Fwd: Building 4 Tunnel Leak

Caasti Contracting Svcs. Inc. (General Contractor)

I met with Dave Kamrowski (GSA Property Manager) this morning to discuss the issues GSA is experiencing this year during the winter months at the tunnel where the new trench drain was installed.

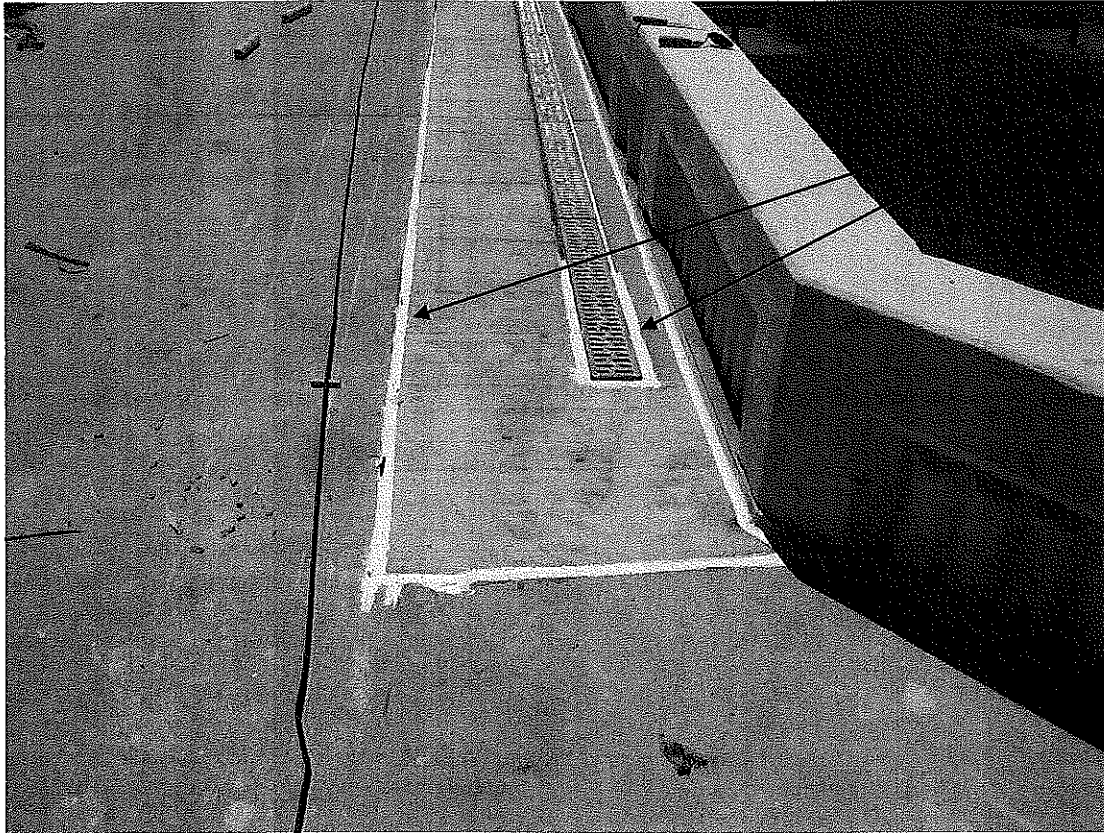
Concrete added around the new trench drain. No sealant at expansion joints.

Adding the sealant.

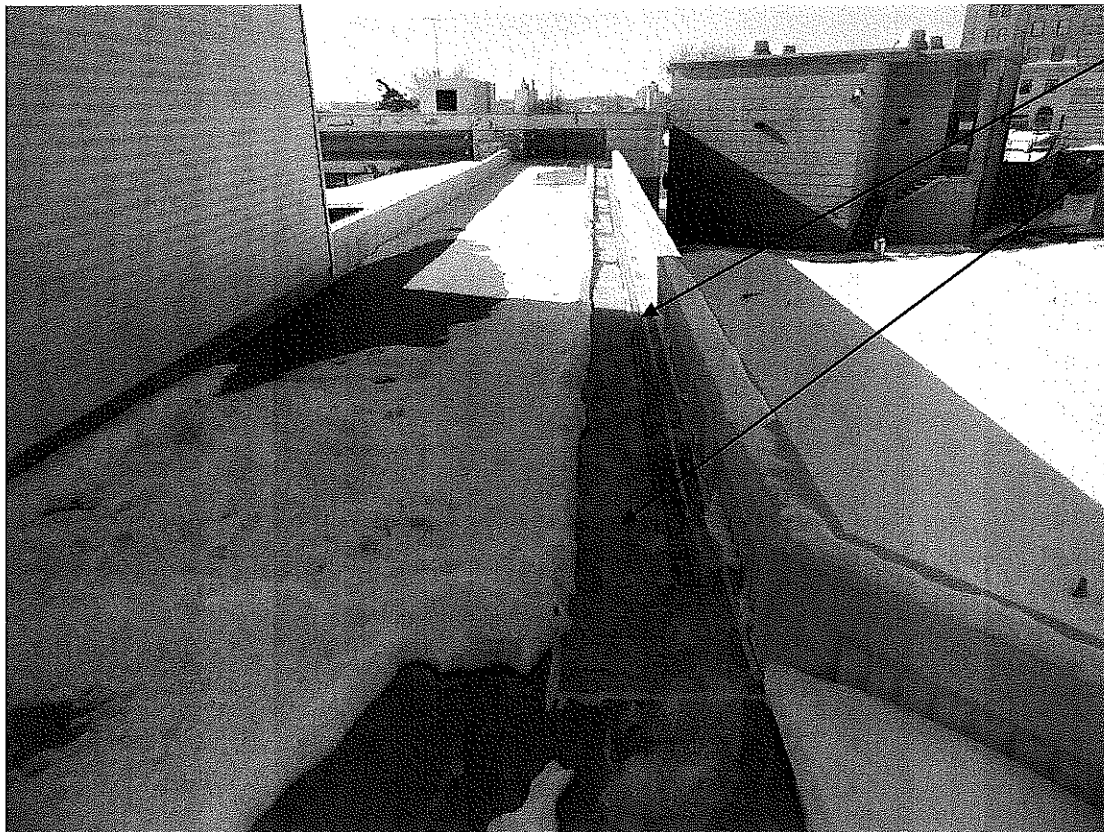
Current March 7th view.

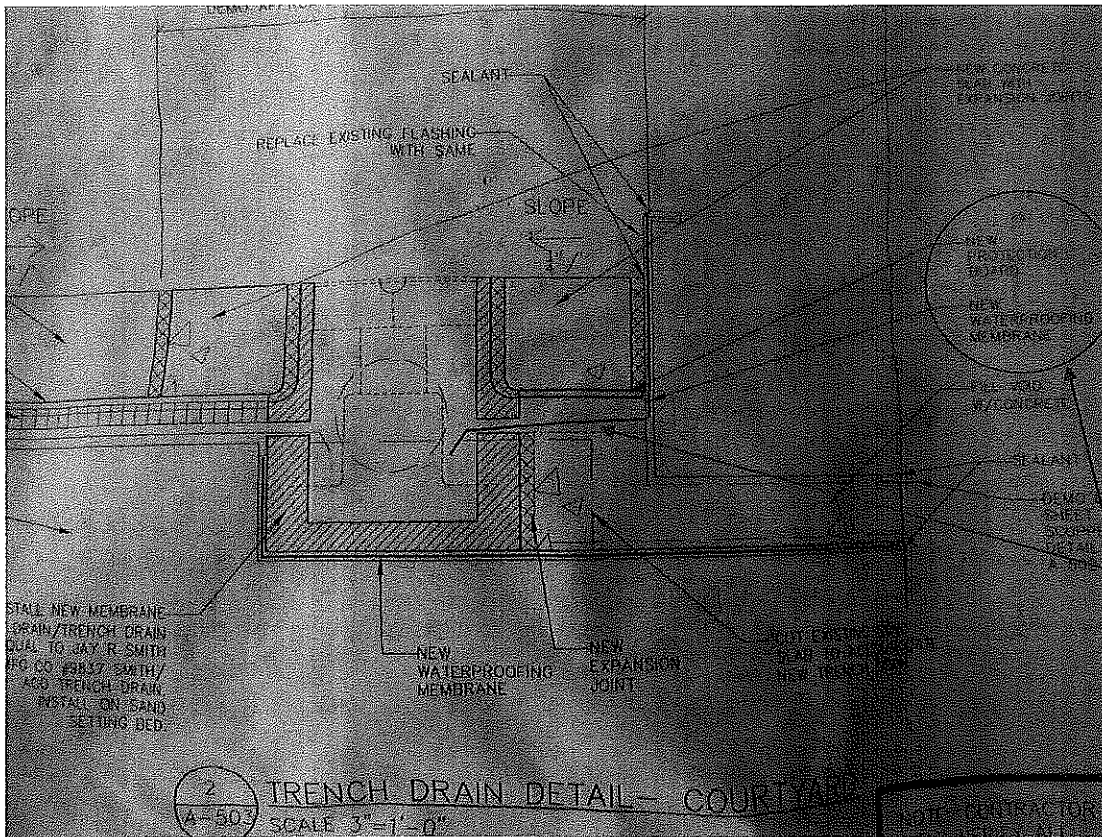
- a) The property manager explained; he is observing more water coming through the tunnel ceiling that before the installation.
- b) Dave instructed his grounds crew to add salt to this area to keep the ice built-up down.
- c) He feels the water is freezing and backing up under the waterproofing and getting into the space below.
- d) See photos included in the end of this report.

GSA using salt to keep the water from freezing and backing up.

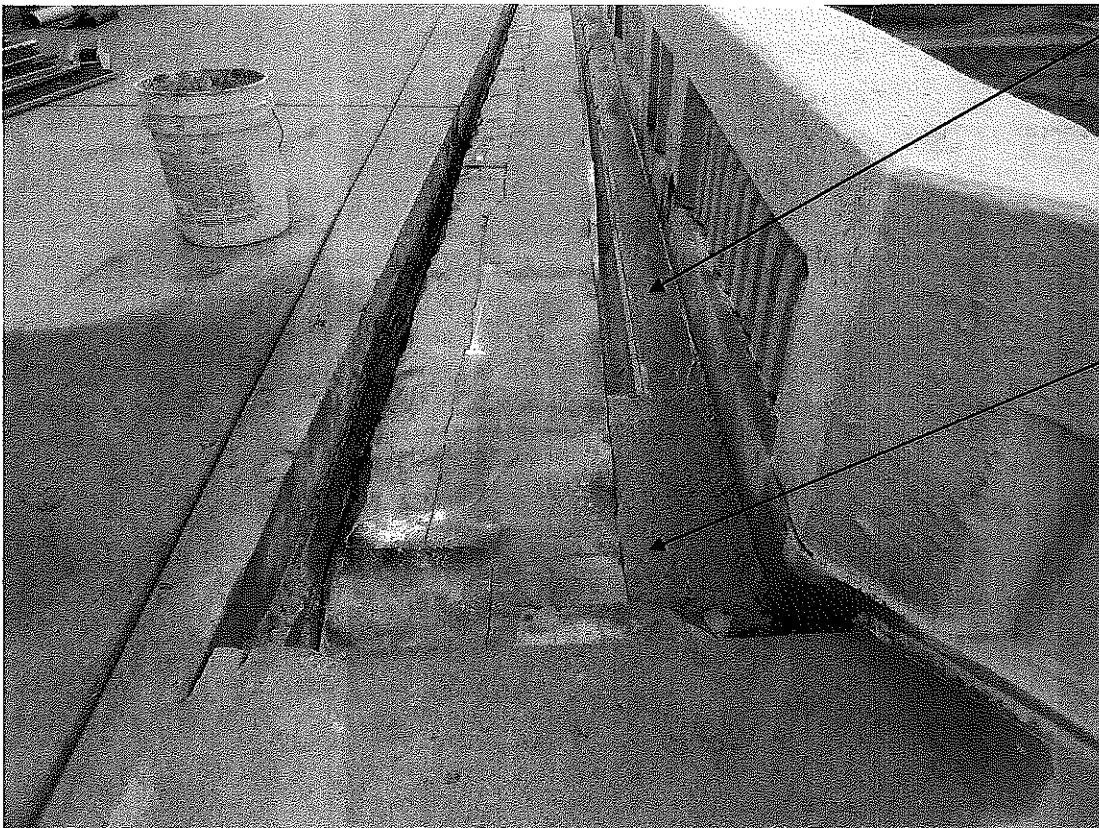
- a) During the time with the property manager we reviewed the contract documents and discovered a deficiency in the contractor's installation.
-  b) It was discovered by the job site photos that the contractor failed to add the proposed flashing shown in the contract documents. This flashing was suppose to run horizontal to the parapet wall and then up the wall into an existing riglet.
-  c) This flashing or waterproofing was not installed. The waterproofing on the other side of the trench drain was installed and tied into the existing as proposed except at the end where leaking is observed.
- d) See photos included at the end of this report showing the deficiency.

The protection board and waterproofing membrane not installed as specified.
